SUBJECT: CRYSTAL RIVER UNIT 3 - ISSUANCE OF AMENDMENT RE: SPENT FUEL EXPANSION
(TAC NO. 75305)

AMENDMENT NO. 134 TO FACILITY OPERATING LICENSE NO. DPR-72-CRYSTAL RIVER UNIT 3

SAFETY EVALUATION BY THE OFFICE OF NUCLEAR REACTOR REGULATION
SUPPORTING AMENDMENT NO. 134 TO FACILITY OPERATING LICENSE NO. DPR-72
FLORIDA POWER CORPORATION, ET AL.
CRYSTAL RIVER UNIT NO. 3 NUCLEAR GENERATING PLANT
DOCKET NO. 50-302

FIGURE 3.9-2
MINIMUM REQUIRED FUEL ASSEMBLY BURNUP AS A FUNCTION OF INITIAL ENRICHMENT TO PERMIT STORAGE IN REGION 2 OF POOL B

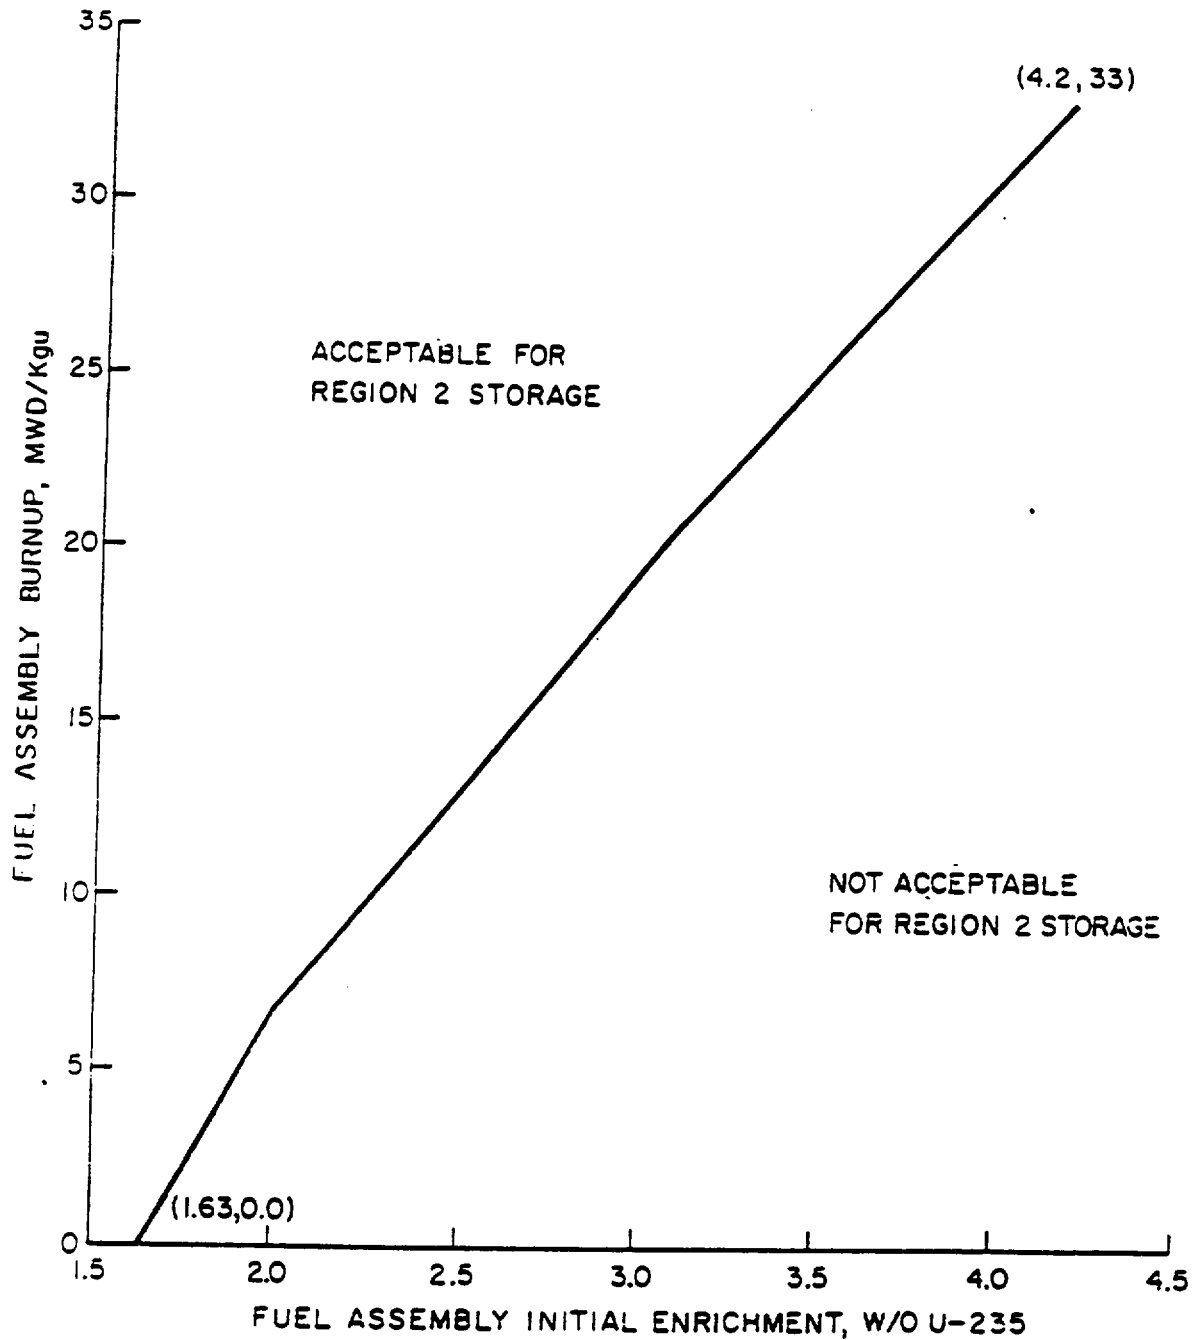
- (1) TS 3.9.13 includes an increase in the allowable nominal fuel enrichment to 4.2 w/o for spent fuel pool B and references Region 1 and Region 2.
- (2) Figure 3.9-2 has been modified to specify the minimum required burnup as a function of initial enrichment to permit storage in Region 2 of pool B.
- (3) TS 5.6.1 specifies the center-to-center distance between fuel assemblies in Region 1 and Region 2 of fuel pool B.
- (4) TS 5.6.3 specifies an increase in the number of spent fuel storage locations from 1153 to 1357 for both pools.

Based on the review described above, the staff finds that the criticality aspects of the proposed modifications to the CR-3 spent fuel pool storage racks are acceptable and meet the requirements of General Design Criterion 62 for the prevention of criticality in fuel storage and handling. The staff concludes that fuel from CR-3 may be safely stored in Region 1 of pool B provided that the U-235 enrichment does not exceed 4.2 w/o. Any of these fuel assemblies may also be stored in Region 2 of pool B provided they meet the burnup and enrichment limits specified in Figure 3.9-2 of the CR-3 TS.

| 4. Storage Pool B: Region 2 | Fuel with initial enrichment and burnup in accordance with Figure 3.9-2 but \leq 4.2 weight percent U-235 |
